Service Bulletin

Subject: A/C AIR TEMPERATURE FLUCTUATION AND / OR LACK OF COOLING	Bulletin No: 07-002/04
	Last Issued: 4/22/2004

2004 RX8

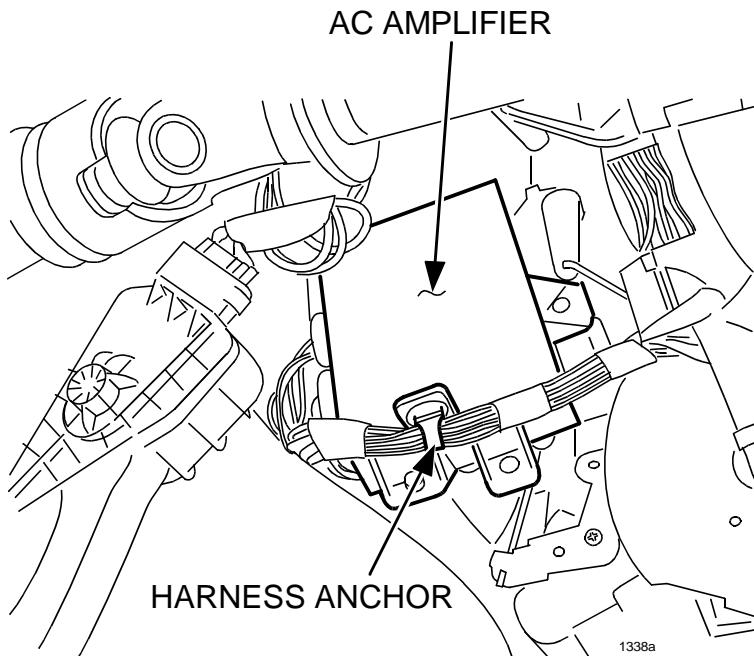
Some customers may complain of lack of air conditioner cooling performance and / or a noticeable temperature fluctuation (cool-warm-cool) from the vents. The cause may be due to improper logic control of the AC amplifier.

1. Verify customer concern.
2. Ensure ignition switch is off and key is removed from ignition switch.
3. Locate A/C amplifier on left side of blower case near accelerator pedal.

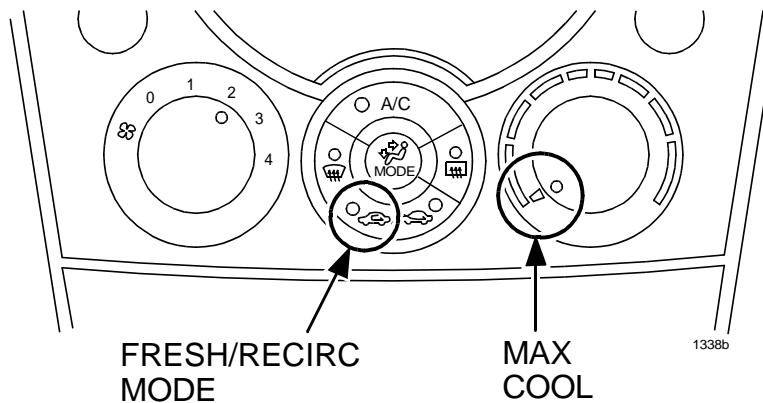
4. Remove 3 screws attaching A/C amplifier to blower case.
5. Remove harness anchor from A/C amplifier.
6. Disconnect harness connectors from A/C amplifier.
7. Replace with new A/C amplifier. To install, reverse removal procedure.
8. Verify that there is no noticeable temperature fluctuation (cool-warm-cool) from the vents.

Part Number	Description	Qty.	Notes
FEY2-61-540	A/C Amplifier	1
